## FREDERICK COUNTY PLANNING COMMISSION

**TITLE:** Westview South MXD – Residential Section Revision Phase 2

**FILE NUMBER:** S-905/SP-98-36 (AP 17804, APFO 17805, FRO 17806)

**REQUEST:** **Combined Preliminary Subdivision Plan/Site Plan**  
The Applicant is requesting Combined Preliminary/Site Development Plan approval to revise the 16.1-acre Phase 2 portion of the overall approved Westview South MXD Residential project to:

**Graphic No. 1: 2016 approved design and density, Westview South Residential ('Part 2' highlighted)**

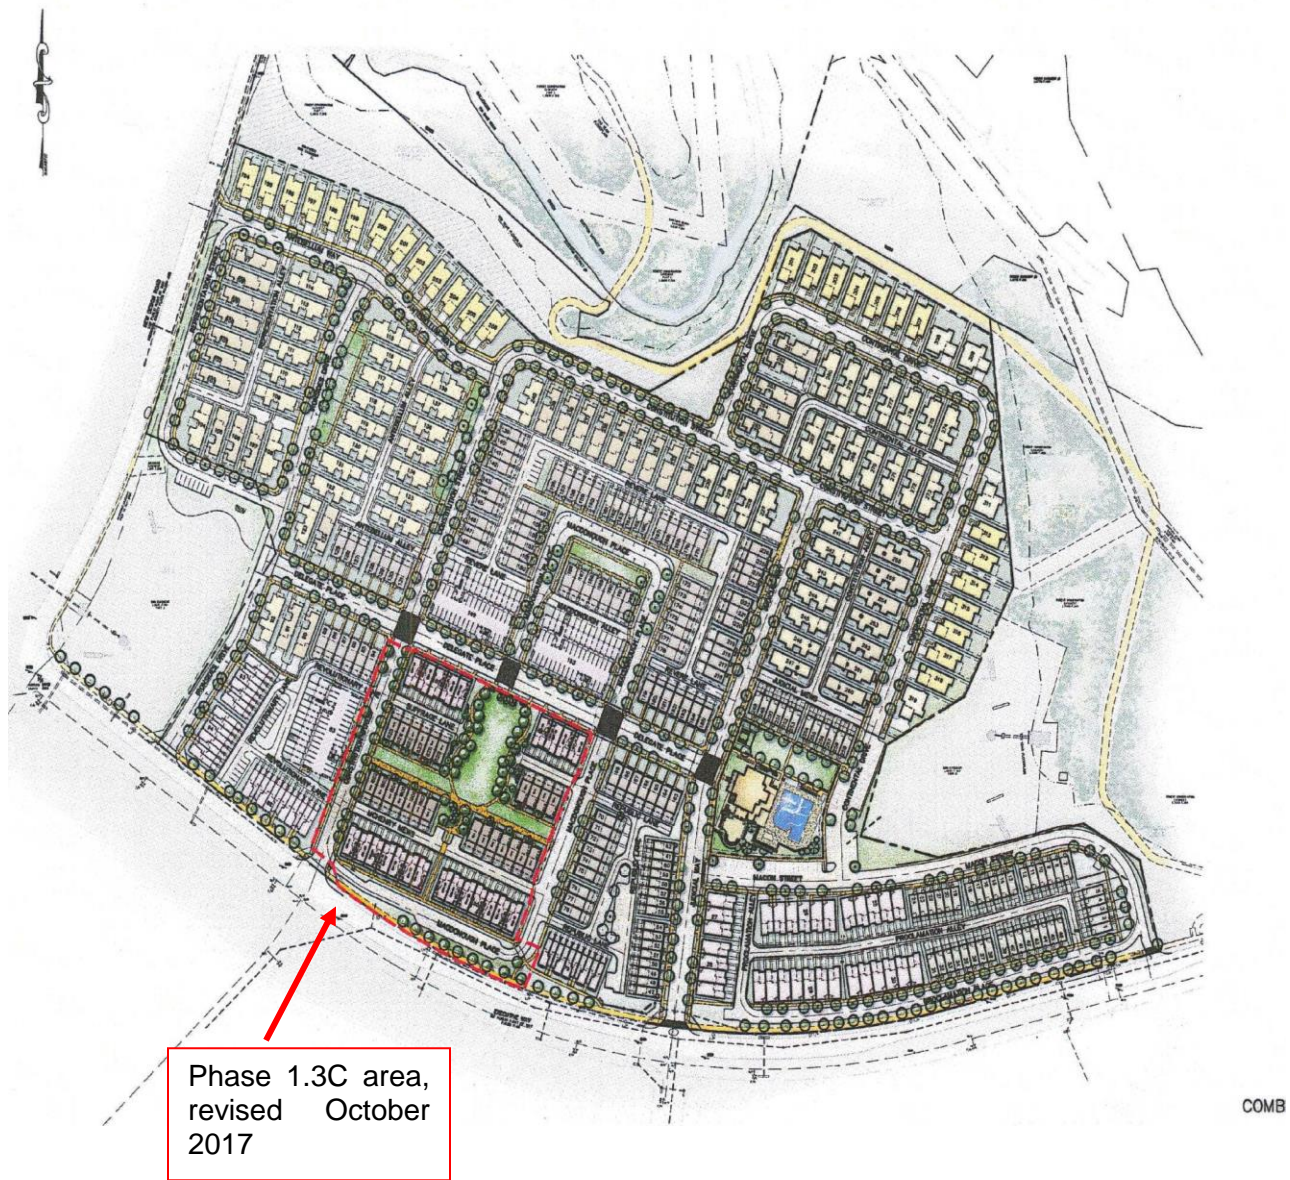
The 2016 Preliminary/Site Plan (AP#15579) for Westview South was approved on January 16, 2016, and addressed an area described as ‘Part 2’ of the project, which is larger than the area currently described as ‘Phase 2’ (refer to graphic no.1). The overall number of units in Westview South was established at 600 as part of the 2016 Preliminary/Site Plan approval. In October 2017, a revision to Phase 1.3C (AP#17503) was approved which reduced the overall number of units in Westview South from 600 to 542 through removal of multi-family units (128), and adding townhomes (24) and ‘2-over-2’ units (46) in a 4.93-acre section of the project. Refer to graphic no. 2 for the amended design for Phase 1.3C.

## Westview South Residential Phase 2 Revision

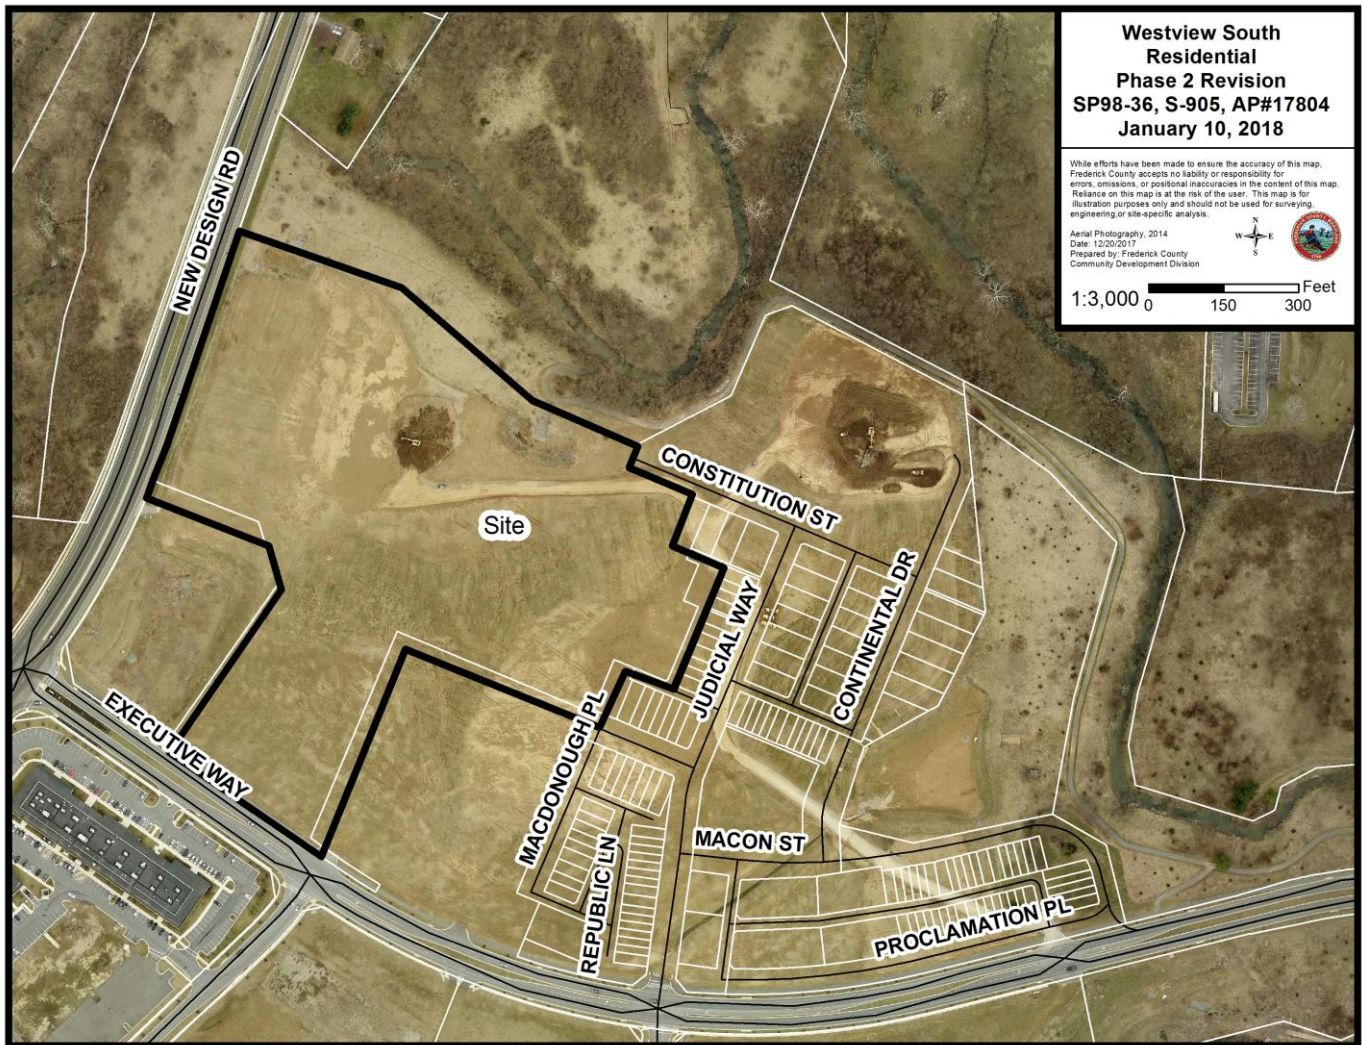
The removal of lots approved on the 2016 Phase II MXD Plan will result in, essentially, an unknown design and unplanned portion of the Westview South Residential project. The placement of mostly front-loaded townhome lots around the perimeter of the 3.1-acre remainder 'void' will impact the future physical layout, lot design and road network in the community. To demonstrate high quality design concepts such as street interconnectedness, traffic efficiency, and pedestrian safety—as required in §1-19-10.500.9--and to show coherence and clarity to the physical design of the future subdivision and greater consistency with the design of Phase I, roadway extensions and connections must be shown within the 3.1-acre remainder area. At a minimum, an east-west connection between Constitution Street and McDonough Place, and a new street from Delegate Place, running in a northward direction, to connect to the above-referenced east/west roadway, must be shown on the Plan.

The lot setbacks for the front-loaded townhomes proposed for Phase 2 differ from the rear-loaded, alley townhome lots; the distinction between these townhome lots' setbacks need to be reflected on a revised building dimension chart in note no. 3 on the Plan. Narrow setbacks correspond to typical dimensions in urban settings, and are appropriate for this Project in that it is generally designed with an urban density range and style of layout. The requested setbacks are also intended to provide flexibility to the Applicant for building placement on residential lots.

The Project generally meets the code requirements by providing landscaping within the open space. Street trees are provided, however additional landscaping with deciduous trees is needed on the north side of Executive Way from Ironsides Drive to Constitution Street to provide buffering for the houses. This may involve placement of on-lot trees (lots 400-407) with shortening of the driveway lengths and increasing the front-yard setback.

There is no change to the general specifications and strategy for the provision of sidewalks in Phase 2, except that the inclusion of front-loaded townhomes in the project creates potential obstacles and obstructions for pedestrians using the sidewalks that cross individual driveways if sufficient distance between the garages and sidewalk is not provided. Planning Commission policy is a minimum 20-ft. separation; the front-loaded townhomes in Phase 2 show a 23-ft. separation between the garages and sidewalks.

5. Prior to signature approval the Applicant shall update the Landscape Plan to include installation of deciduous trees on the north side of Executive Way from Ironsides Drive to Constitution Street.

6. Prior to signature approval, the Applicant shall update the Landscaping Plan to include deciduous street trees along McDonough Place in front of lots 543—549.

- d. Describe the hatching area shown on Plat Sheet No. SP-4
  - e. Revise Note No. 3 (Proposed Building Dimensional Requirements) to add the BRLs for the new front-loaded townhome lots; Remove the 'Multi-Family' column from the chart.

- f. Add details for the 28-ft. wide, front-loaded townhomes to the Detail Sheet No. SP-8.
  - g. Remove the 16-ft. wide, alley loaded townhome detail from Detail Sheet No. SP-8, as there are no 16-ft. wide townhome lots within Section 2.

9. Prior to signature approval, depict the full roadway and pavement width in front of lots 543—549 on McDonough Place.
10. Prior to signature approval, depict within the 3.1-acre remainder area, complete street details for an east-west connection between Constitution Street and McDonough Place, and a street from Delegate Place to connect to the above-described east/west street.

11. Add a full sized amenity plan to the full Plan set and include the following revisions:
  - a. Show specifications/details for the benches, waste receptacles, and play equipment
